Addendum Three

April 5, 2012

PROJECT: SOUTH TOWER MECHANICAL RENOVATIONS UNIVERSITY OF SOUTH CAROLINA COLUMBIA, SOUTH CAROLINA STATE PROJECT NO. H27-6082-NA	SKETCH NO: SK-A-1	ADDENDUM: 3	Swygert & Associates CONSULTING ENGINEERS <small>DBA Swygert & Assoc., Ltd. Telephone (803) 791-9300 Post Office Box 11686 Fax (803) 791-0830 Columbia, SC 29211 mail@swygert-associates.com</small>
	REFERENCE: A1.00	PROJECT NO: 11360	
	DATE: 04.04.12

1 PARTIAL BASEMENT FLOOR PLAN
 SK-A-1 1/4" = 1'-0" REFERENCED ON:

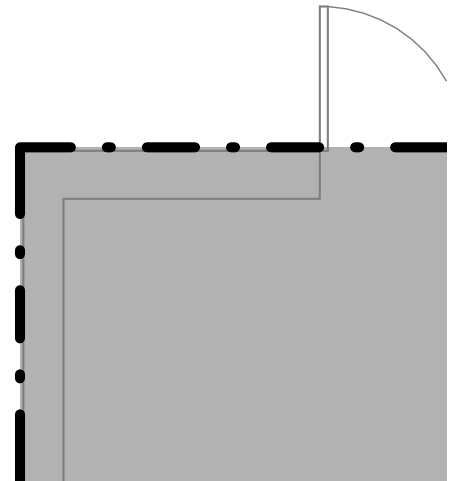
3. Revision: Reference Drawing A1.00, Basement Floor Plan. Reference SK-A-1. A new wall has been added in Basement S101 to protect new electrical equipment.

PARTIAL TYPICAL REFLECTED CEILING PLAN - LEVELS 2-18

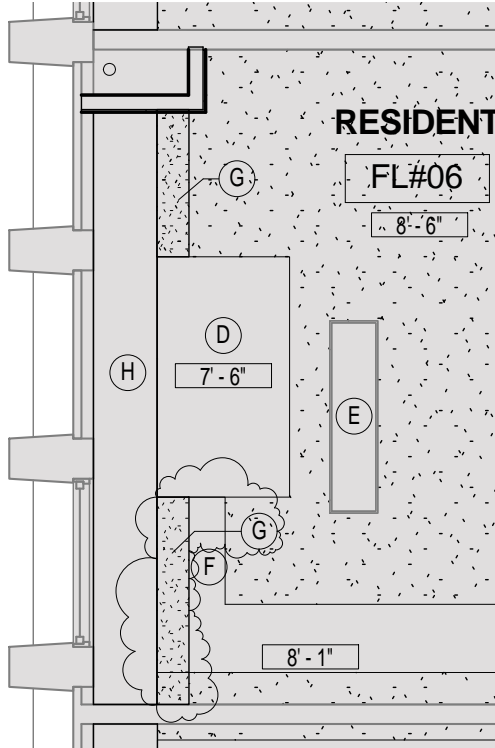
5. Revision: Reference Drawing A2.2, Typical Reflected Ceiling Plan Levels 2-17 and A2.3 18th Floor Reflected Ceiling Plan. Reference SK-A-2. A keynote G has been added to clarify the extent of the new spray texture finish. This keynote applies to levels 2 – 18.

NOTE : A KEYNOTE G WAS ADDED TO CLARIFY EXTENT OF NEW SPRAY TEXTURE FINISH. THIS APPLIES TO FLOORS 2-18.

SKETCH NO.:
SK-M-1

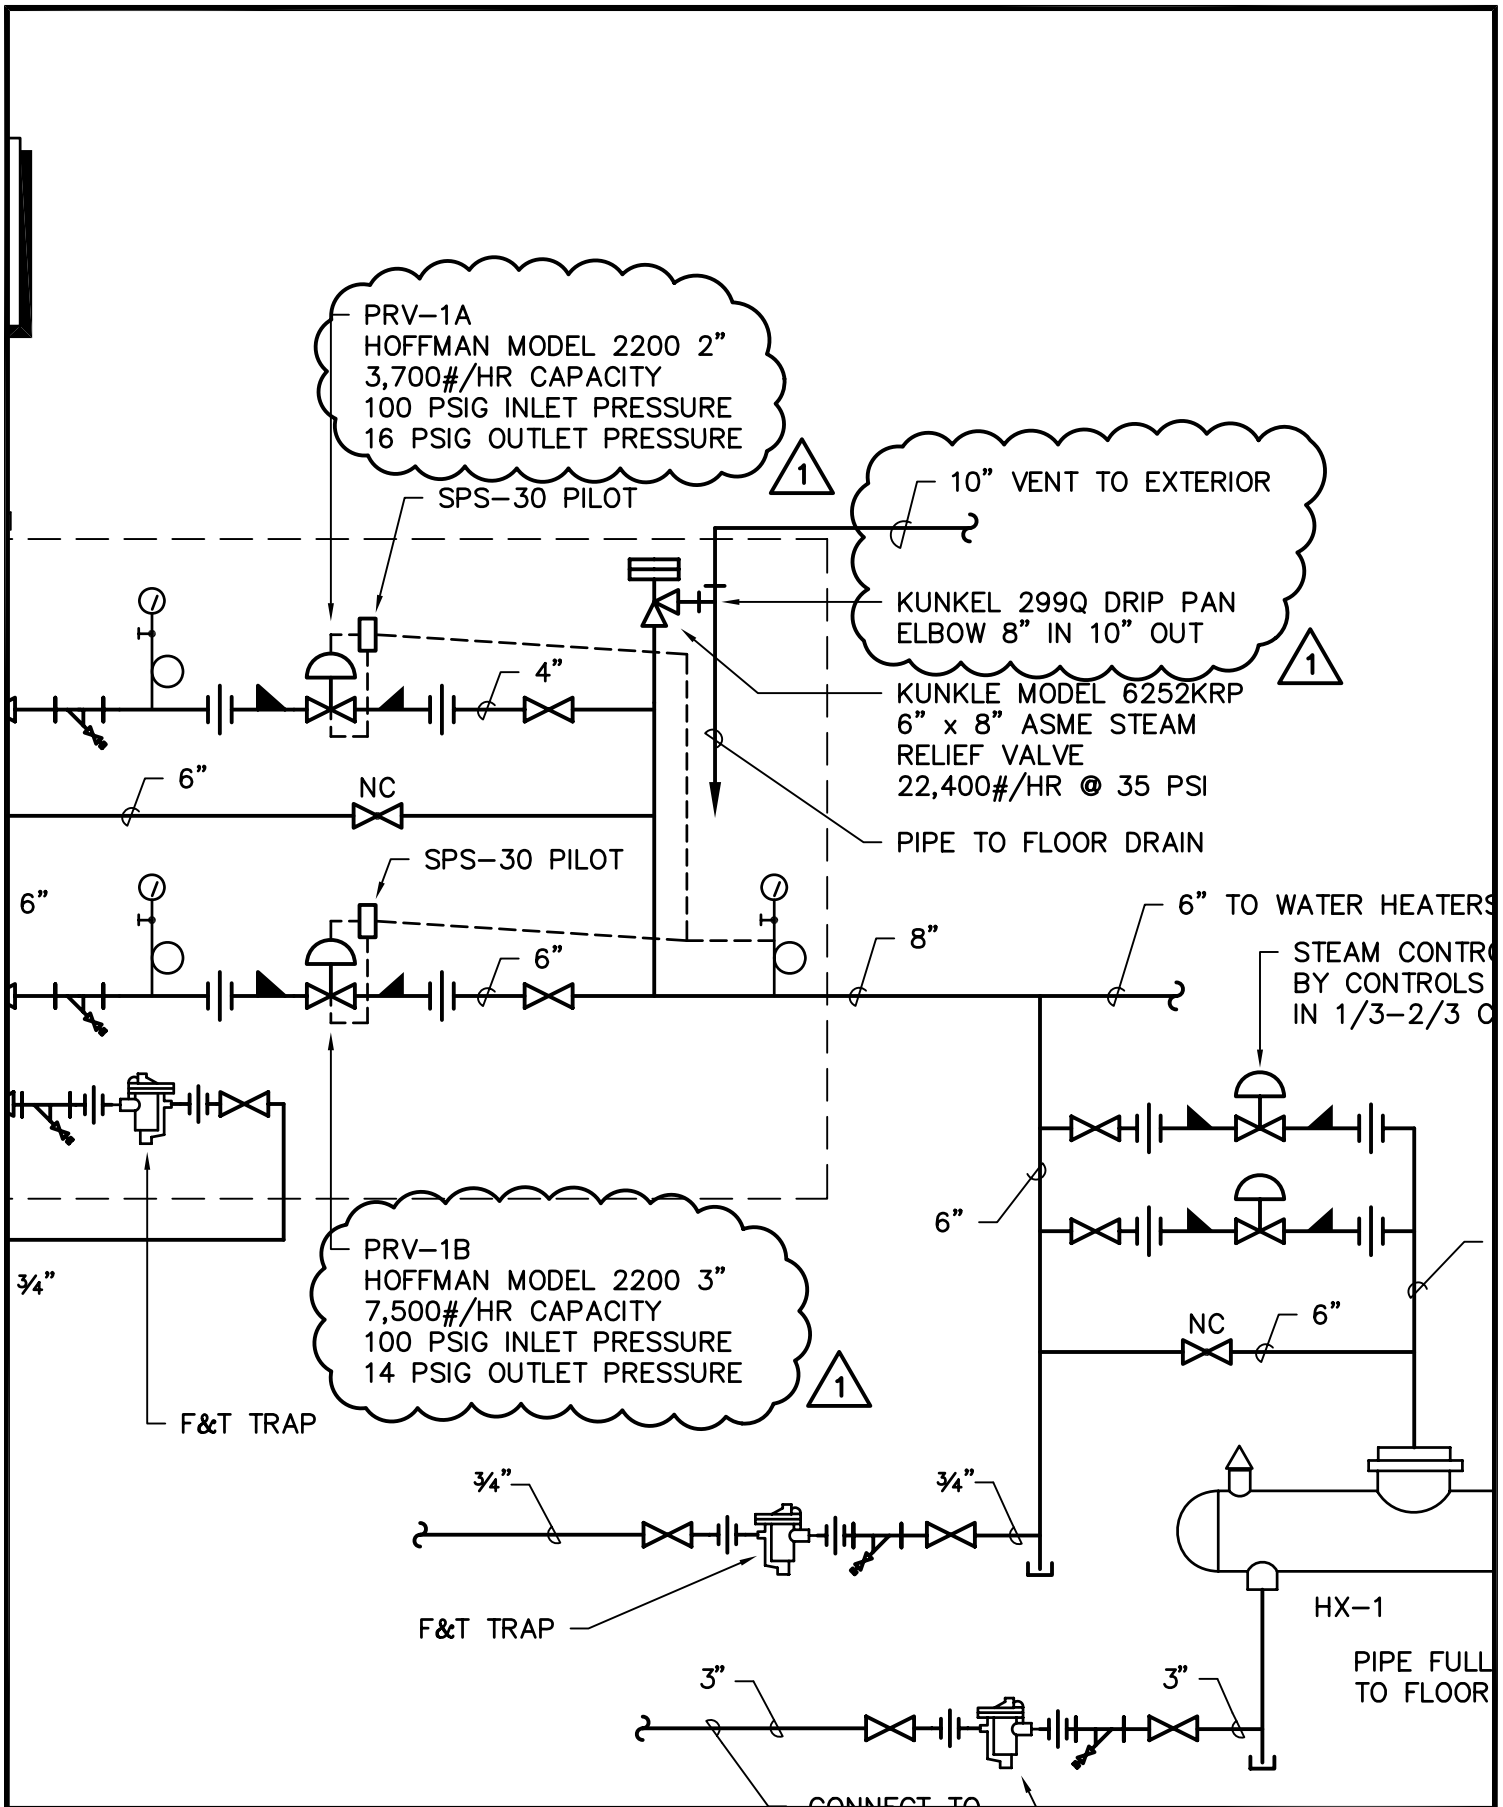
9. Revision: Reference Drawing M3.2 Piping Details. Reference SK-M-1. This sketch revises the PRV valve and vent sizes.
10. Revision: Reference Drawing M4.1 Notes and Schedules. Reference SK-M-2. This sketch revises the Condensate Return Pump Schedule and shows information for CRP-2.

2 PIPE RISER SCHEMATIC
M3.1 NO SCALE

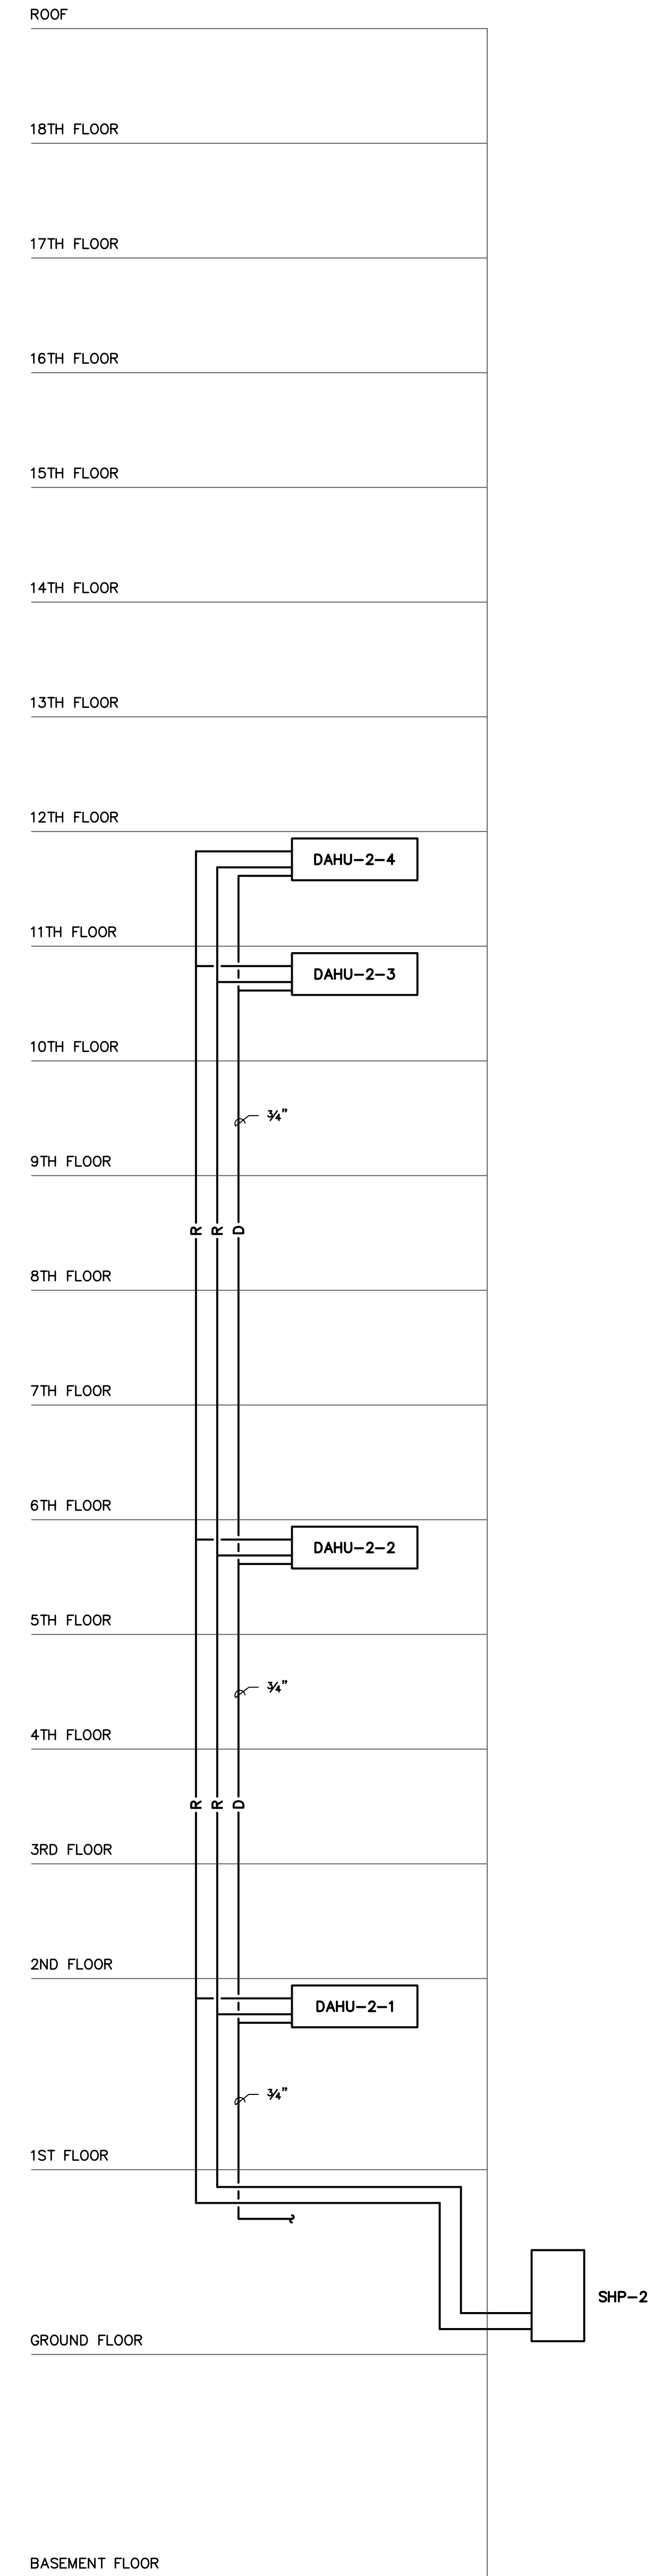
7. Revision: Reference Drawing M2.00B, Basement Floor Plan Phase B. Change PRV vent size to 10”.
8. Revision: Reference Drawing M3.1, Risers. See attached revised sheet M3.1 showing revisions to the pipe riser detail.

Provide 24" long flexible connectors on all pipe riser branch connections as shown on pipe riser detail on sheet M3.1.
